ORDER UNDER SECTION 96 (2) OF ACT, III OF 1901.

With reference to his application, dated 20th Sept. 1918
Mr Munshi Harmanji Guranji Peshawari Ardeslur is informed
that the plan submitted by him for building a lungalow with
cut house on plot No 8/14, Survey Sheet 914
situate in _____ Street, Garden
Quarter, is approved, and permission to build in accordance therewith is
granted. The building to be erected subject to the By-laws and Rules of the
Municipality.

Applicant's name Honourable J. S. Jagan & Peetong's address
 Whether he is the owner of the plot on which it is proposed to build Yes
 Plot under whose control Government
 Whether it is permanent or temporary Permanent
 The work proposed To build a bungalow with outhouses

PROPOSED DESIGN
FOR
BUILDING ON PLOT NO. 54 SHEET 14

GROUND FLOOR PLAN

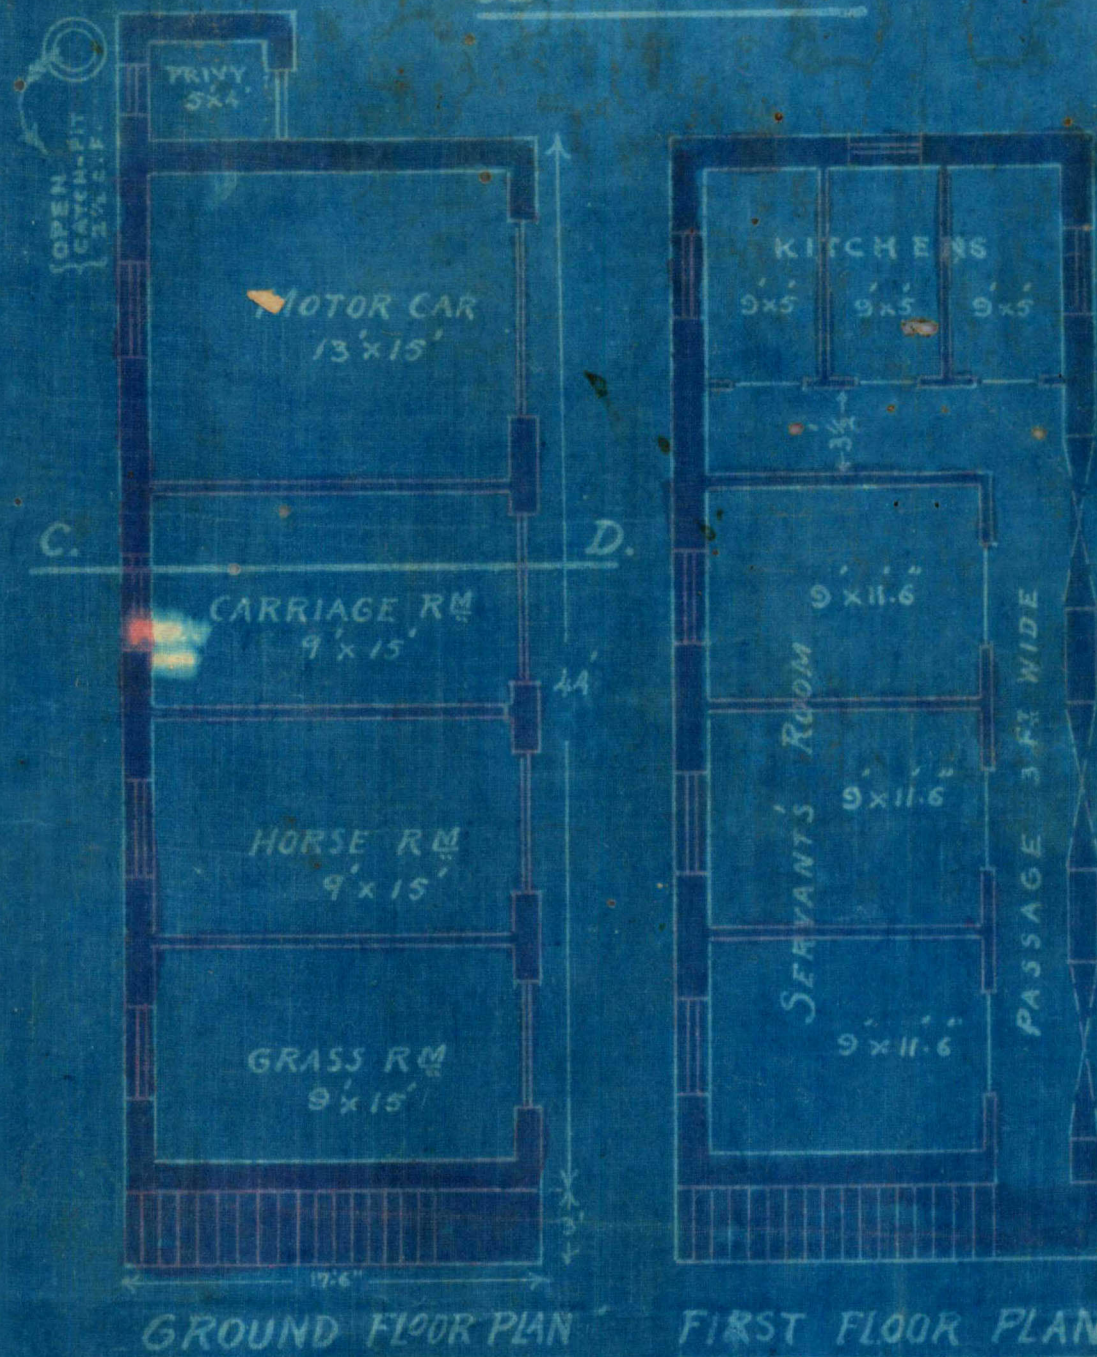
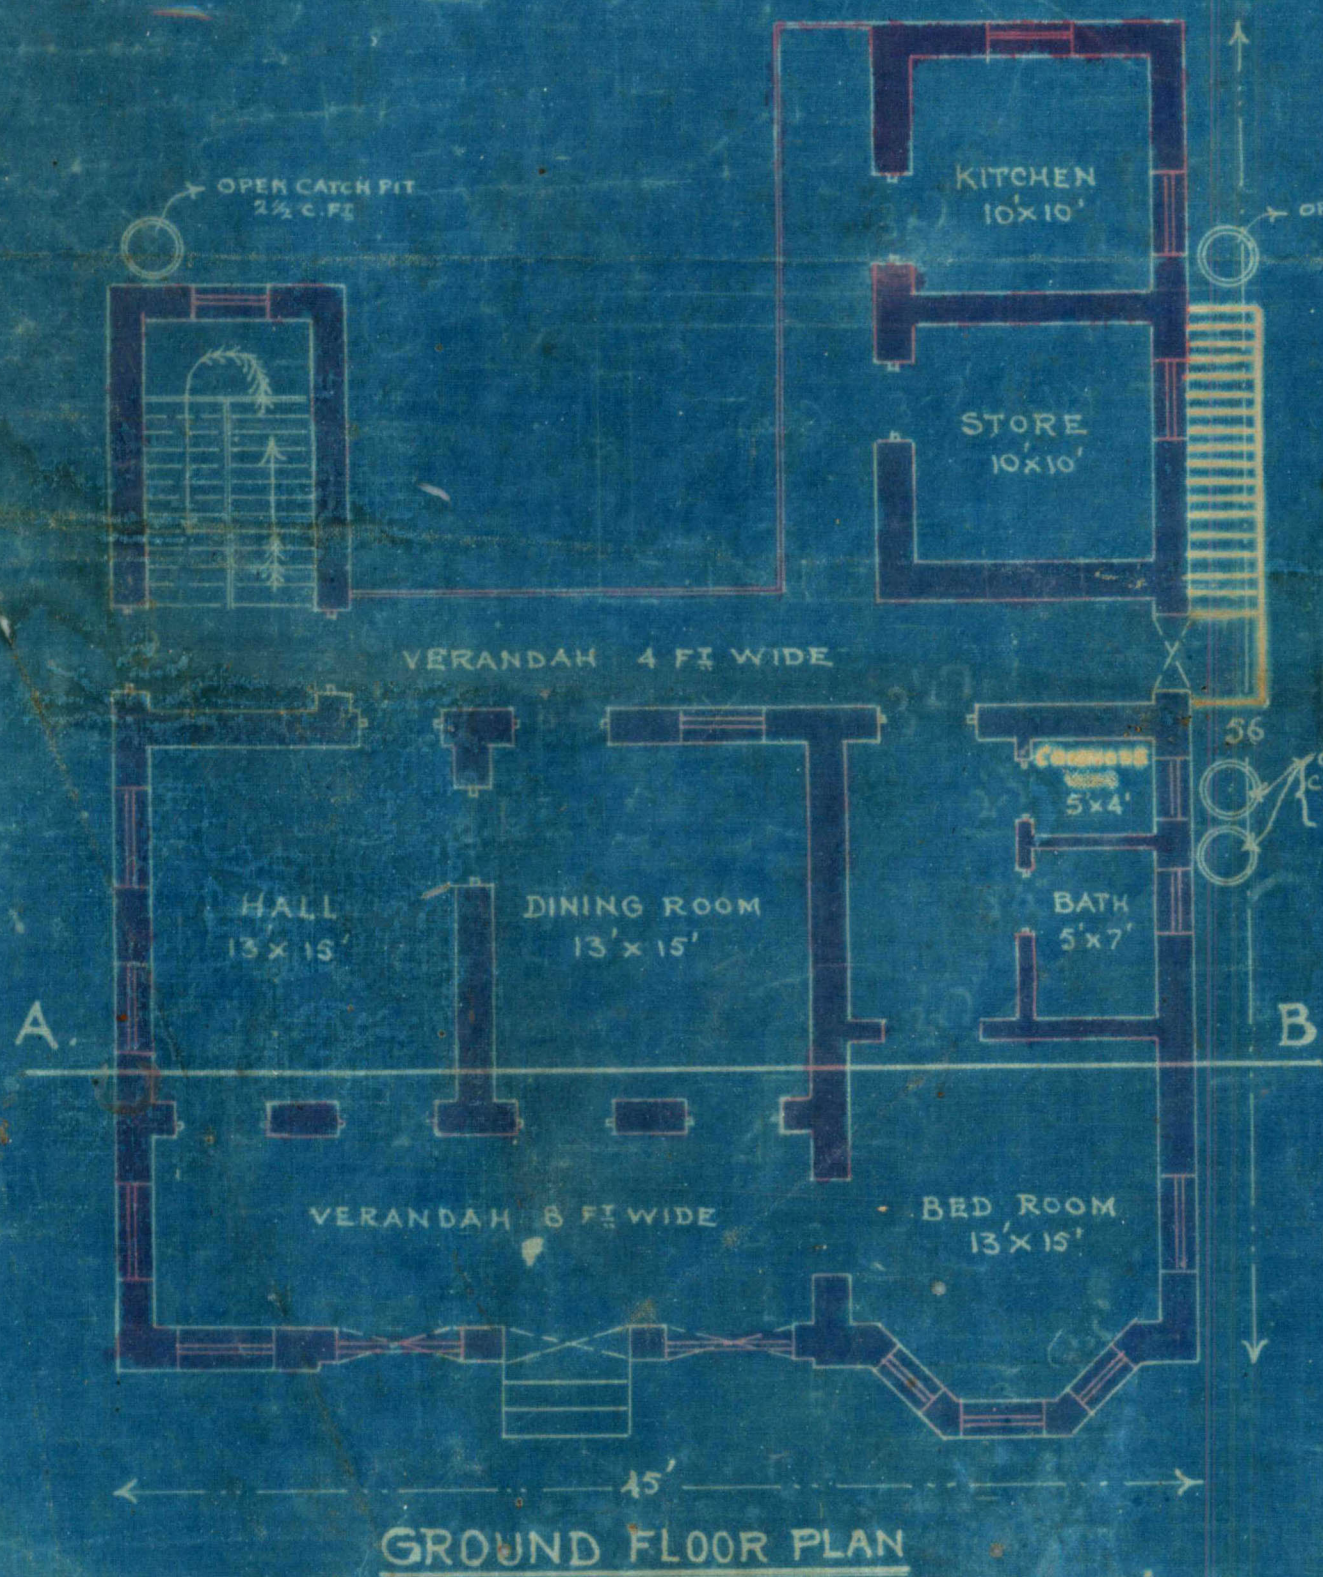
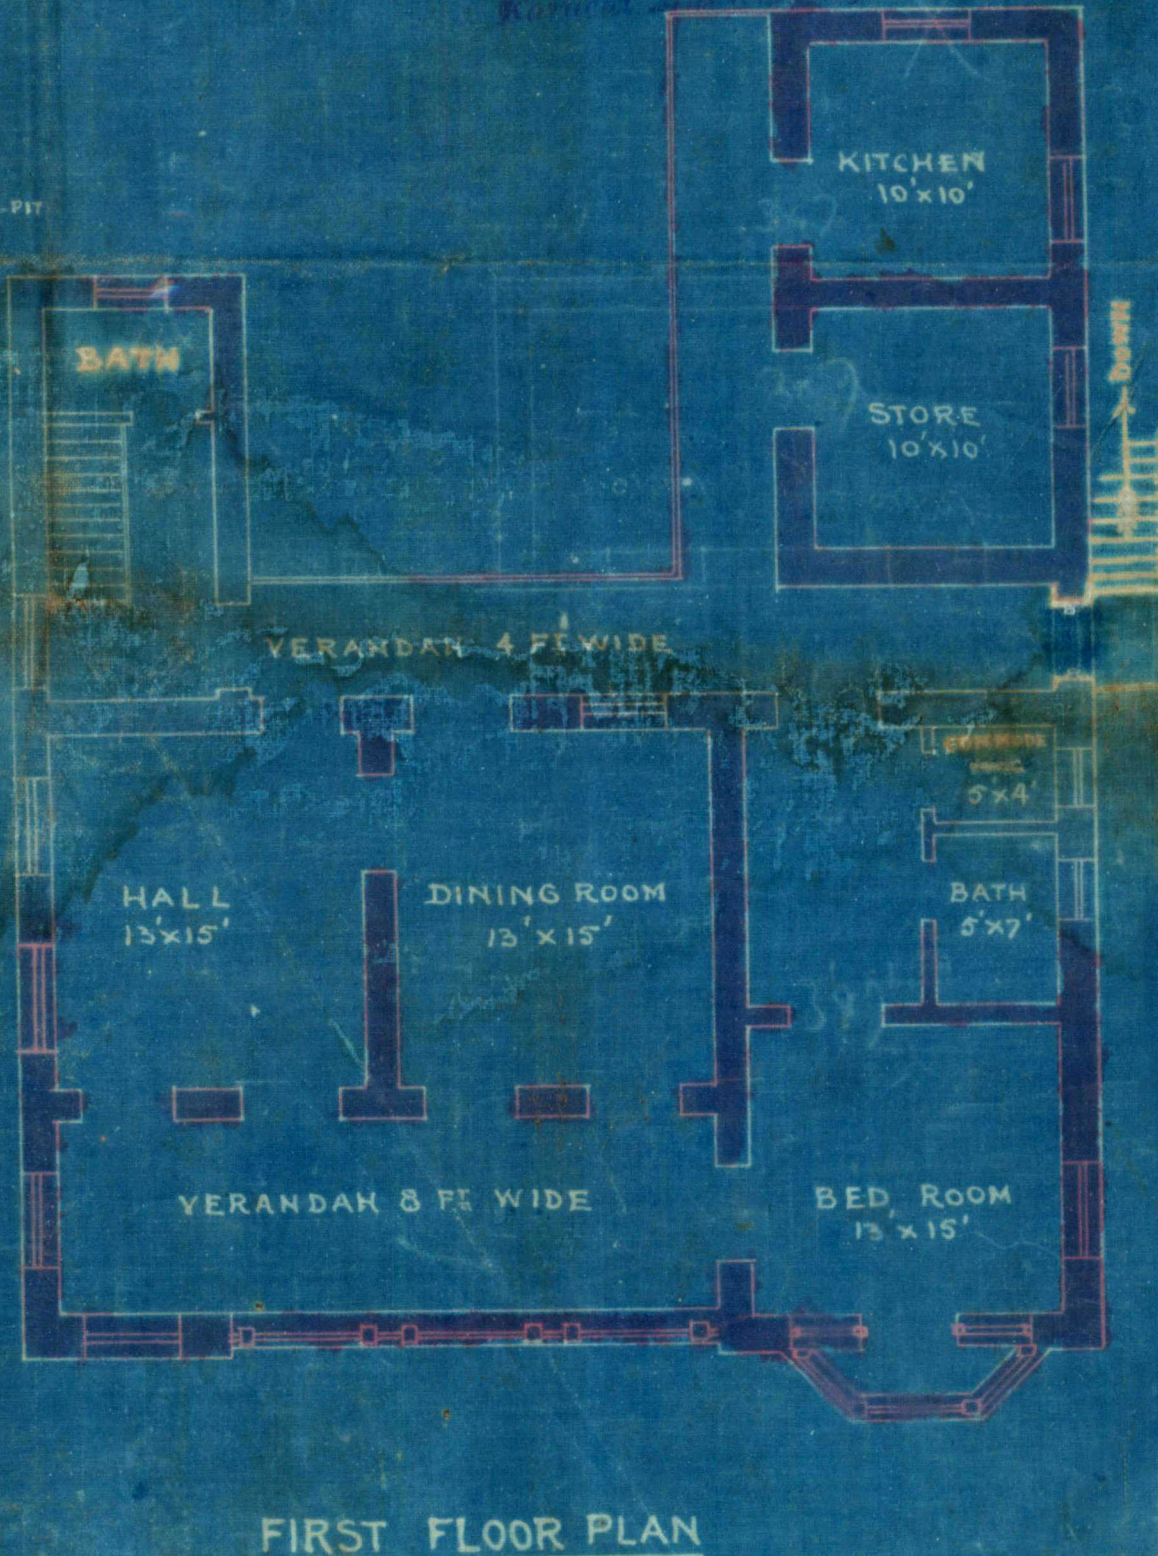
1. Cooking accommodation
be provided for servants.
Cooking in living Room
provided permitted.
2. The linen copy of the plan
must be coloured.

*No objection
(Sewage's privy must have a
catchpit)*

Building Surveyor's report Sir, with respect to this I beg to
that there seems no objection in passing the p^l
provided the man gets the sanction of C.D.O.
The servants' latrine pits are shown already as the
himself had been here in office on 27/9/18.

Remarks Sir With reference to this I beg to report
that in accordance with the City Health
officers instruction servants' quarters also
require separate Cook room. if so the
applicant may ~~be~~ asked to comply
Request your order

Sir
with respect to
this I beg to report
that there is no objection
now in opposing the
plan. since it is
amended as required
23/10/18.

Cooking accommodation must be
provided for the servants & order.
Cooking in the living room cannot be
permitted. The linen copy of the plan
must be coloured.
